Amendments to the Drawings

REMARKS

FIG. 1b

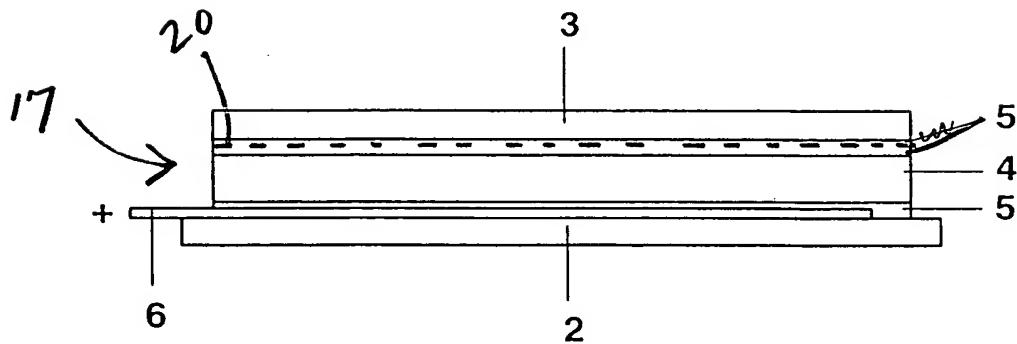
Fig. 1b has been amended to show the phosphor mixture and reference numbers have been added for the phosphor mixture and discharge vessel.

Fig. 1b has been amended to show the phosphor mixture and add reference numbers for the phosphor mixture and discharge vessel. No new matter has been added. Support for the drawing amendment can be found in the Specification as originally filed, in particular, page 8, line 27 through page 9 line 18. The Specification has also been amended to reflect the drawings changes.
